# UNITED STATES PATENT AND TRADEMARK OFFICE

APPLICATION NO.	FILING DATE	FIRST NAMED INVENTOR	ATTORNEY DOCKET NO.	CONFIRMATION NO.
09/674.039	10/25/2000	Yasuo Himuro	Q59956	9058

# Office Action Summary

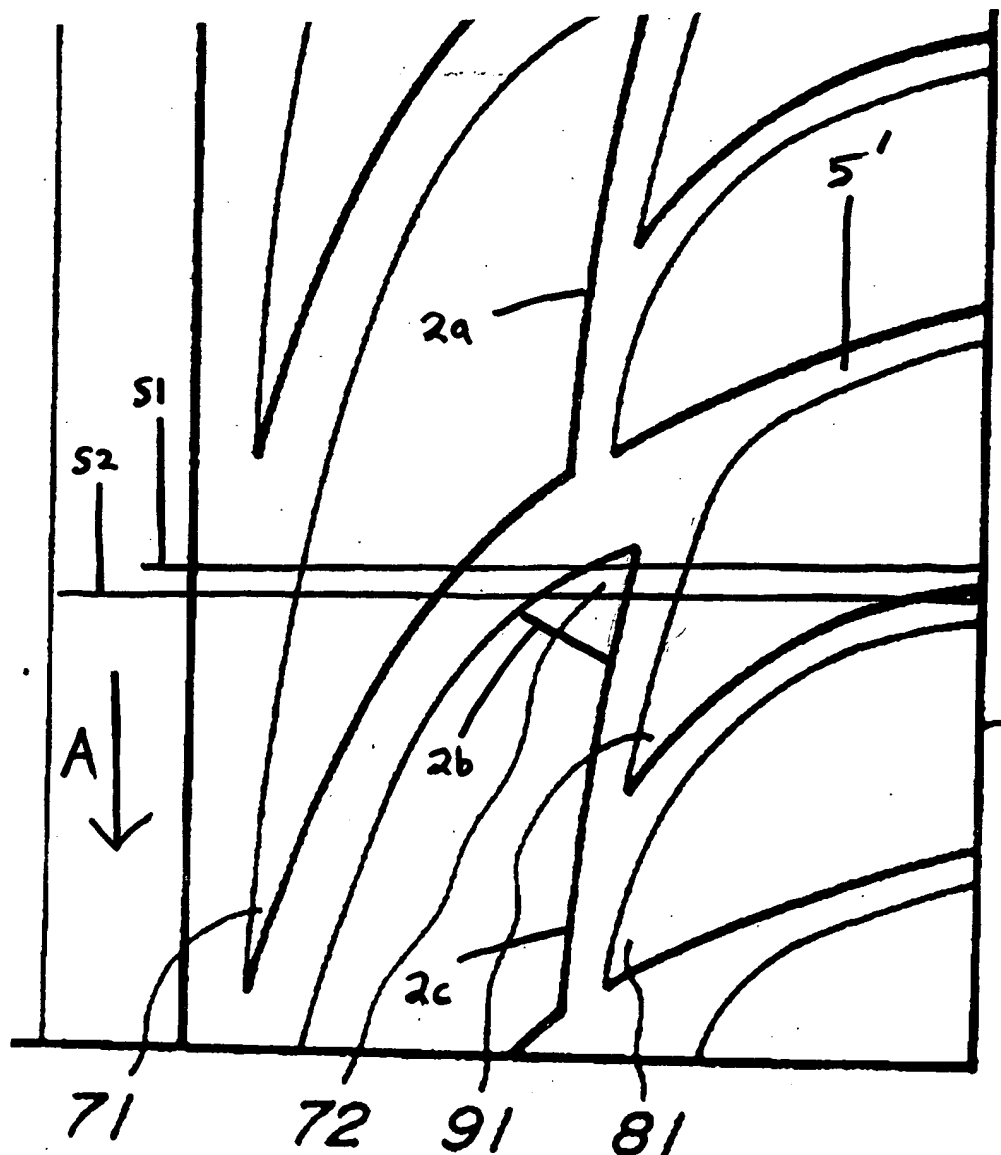
The claimed tire is anticipated by Europe '310. The claimed pseudo land portion reads on the acute angle corner portion 72 of the block, which is beveled over a distance of 10-30 mm from a tapered end thereof in a longitudinal direction so as to gradually shallow from the tapered end toward a width widened portion. Europe '310 teaches that the beveling obtains *smooth conduction of branching and joining of water flow*. In order to facilitate understanding of the application of Europe '310 against the claims, the following copy of an enlargement of a portion of figure 1 of Europe '310 is provided:

The markings for S1, S2, 5', 2a, 2b and 2c and A were added by the examiner.

Markings S1, S2 and 2b are not to scale.

As to the pseudo-land portion comprising "a slant face on a ground contact side so that the slant face does not contact a ground surface" (claims 3, 31), Europe '310 satisfies this subject matter since the upper surface of the beveled corner 72 is below the ground contacting surface of the tread.

As to "a pseudo-land portion formed in the circumferential groove", the beveled portion 72 is located "in a circumferential groove" as indicated by figure 1 wherein the outer upper edge of "the circumferential groove" is defined by one outer upper block edge (2a), the edge (2b) at which the beveled portion joins the ground contacting surface of a block and the outer upper edge (2c) of a next block. The phrase "circumferential groove" is sufficiently broad so as to read on the above non-linear outer edge (2a, 2b, 2c); it being noted that edge (2b) directly corresponds to the edge at maximum height 35 shown in figure 2a of applicant's disclosure.

As to "an end part at a larger side of the cross sectional area of the pseudo-land portion", the following comments are made: The cross sectional area at line (S2) of the beveled corner 72 near the ground contacting surface is larger than the cross sectional area at line (S1) near the apex of the beveled corner 72. The claimed end part reads on the portion extending between edge 2b and cross sectional area at line (S2). This end part is "close" to the opening of the slant groove since the beveled corner faces the slant groove 5' and is closer, for example, to slant groove 5' than the center circumferential rib; it being emphasized that "close" is a relative term.

As claims 2 and 32, the cross sectional area of the beveled corner increases in a given circumferential direction (circumferential direction A).

As to claims 4, 5 and 31, the first groove wall reads on the outer groove wall having edges defined by the outer upper block edges and the upper edge of the beveled corner (edges 2a, 2b, 2c).

As to claims 7 and 8, the height of beveled corner 72 decreases toward slant groove 5'.

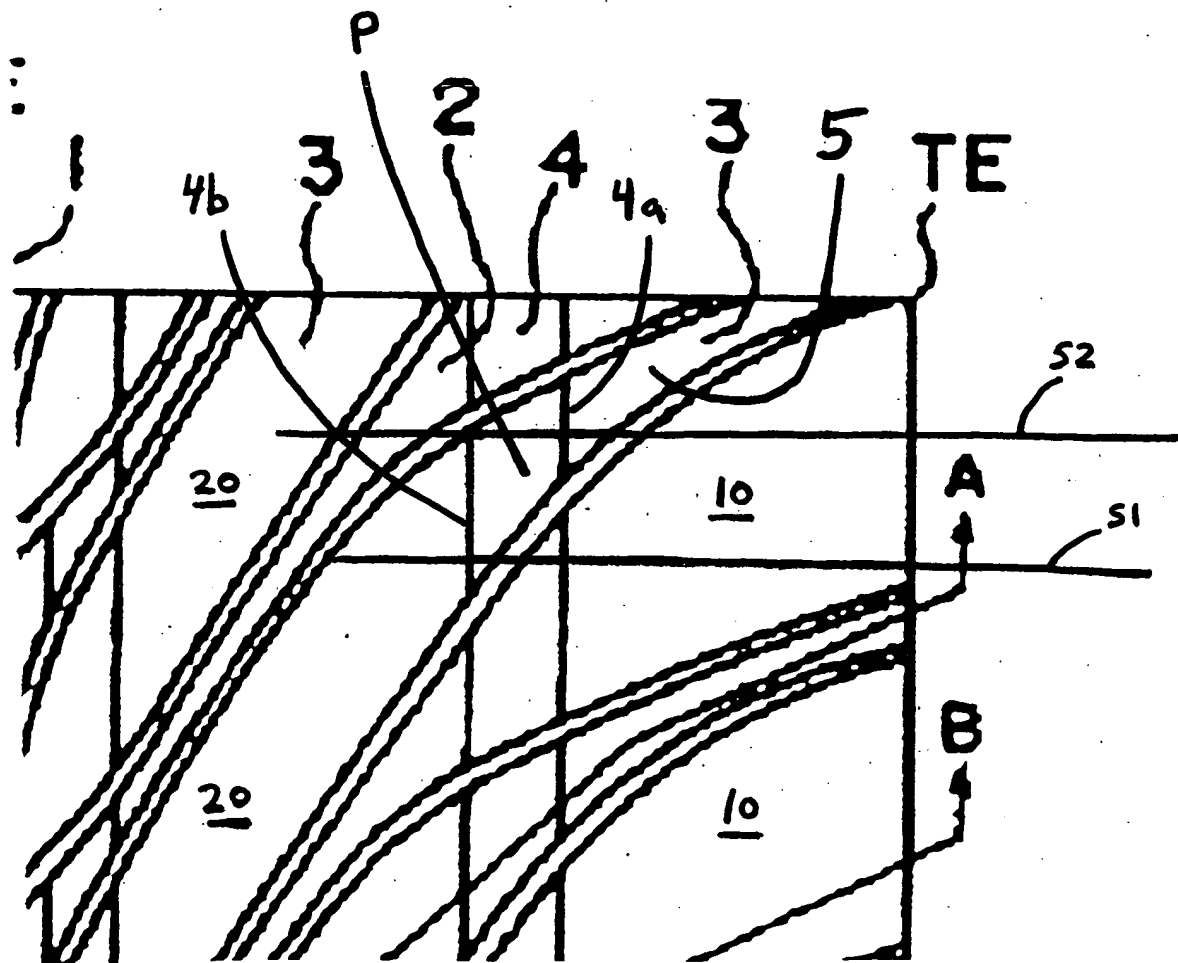
which have decreasing height toward a slant groove. The claimed circumferential groove reads on the circumferential void defined between the inner row of land portions and the outer row of land portions. See figures 1-3. The decreasing height of the projections of the rib towards the slant groove 4 inherently promotes water flow as claimed. An enlarged copy of a portion of figure 1 of Japan '024 is provided below:

The markings P, 4a, 4b, 5, 10, 20, S1 and S2 were added by the examiner. 4a and 4b are the upper edges of the "circumferential groove" 4. P is the pseudo land portion. 5

is the slant groove. 10 are the land portions of the outer row. 20 are the land portions of the inner row. S1 and S2 are lines indicating different cross sectional area locations.

As to the "pseudo-land portion comprising "a slant face on a ground contact side so that the slant face does not contact a ground surface" (claims 1, 31), Japan '024 satisfies this subject matter since the upper surface of the pseudo land portion P (inclined end portion of inner land portion 20) is below the tread surface.

As to "a pseudo-land portion formed in the circumferential groove", the pseudo land portion P (end portion of inner land portion 20) is in the circumferential groove 4 since it is located within the boundaries of the upper edges 4a, 4b of the circumferential groove.

As to "an end part at a larger side of the cross sectional area of the pseudo-land portion", the following comments are made. The cross sectional area at line (S2) of the pseudo land portion P (end portion of inner land portion 20) is larger than the cross sectional area at line S1. The claimed end part reads on a portion defined between the edge of the pseudo land portion and the line at S2. This end part is "close" to the
